Oasis Circular No.: 2209

Subject: China MSA issued notice of correction to chart in respect of unidentified underwater objects off Fuzhou port and Ningde port

**Positions of 3 grounding incidents from 2020 to 2022**

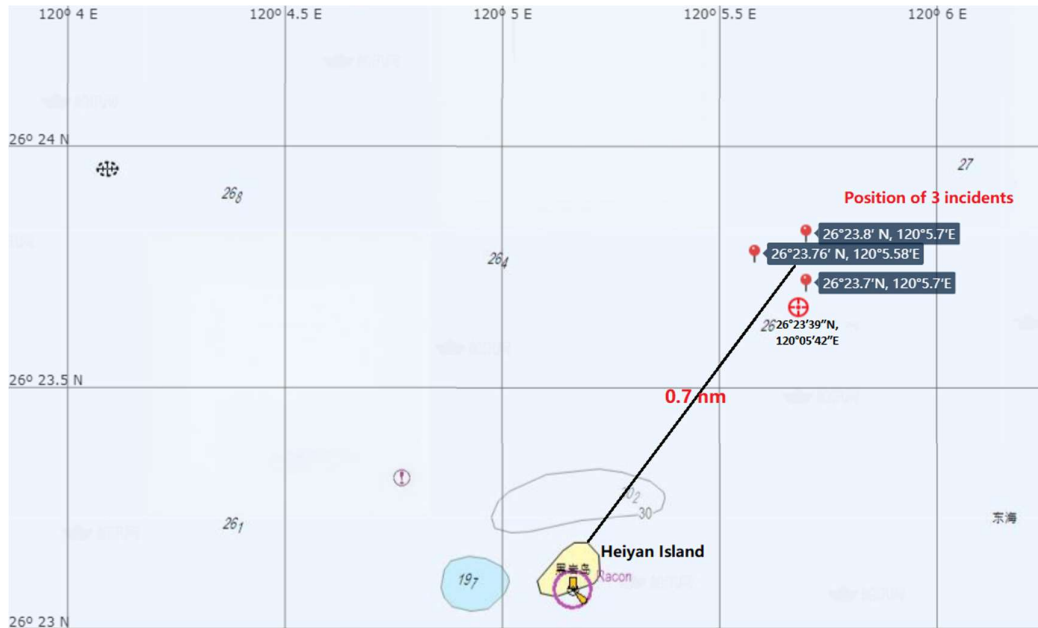
On 10 Oct 2022, China MSA issued No. 41 Notice of Correction to Channel Charts of Chinese Coastal Ports, in which they requested ships to remark the warning statement "Unidentified underwater objects were found in northeastern waters of Heiyan Island, Sansha'ao, Lianjiang, Taiwan Strait, within a radius of one nautical mile from the center of the circle: 26°23'39", 120°05'42"E" on the 3 relevant nautical charts, including No. 62001 (2022-970), No. 62151 (2022-202) and No. 2310 (2022-904). The source of this correction notice is No. 32/22 Navigation Warning issued by Fujian MSA on 10 Sep 2022. Details are illustrated as follows:

serious damages to the ships' hulls and necessitated complex salvage operations. The draught of those ships at the time of grounding varied from about 7 metres to 15 metres, with two ships laden whilst the third one in ballast. The positions of these 3 grounding incidents are listed as follows and illustrated below:

1. 26°23.7'N, 120°5.7'E
2. 26°23.8' N, 120°5.7'E
3. 26°23.76' N, 120°5.58'E

Ships which plan to call Fuzhou Port (including Luoyuan Port, Kemen Port, Huadong Shipyard and Ningde Port (including Zhangwan Terminal, Datang Powplant Terminal, Dingxin Terminal, etc) shall add the above warning statement in the nautical chart before the voyage commences and keep away from those waters when the ship enters into or departs from the aforesaid terminals and shipyards. A map of this area is appended below for your ready reference.
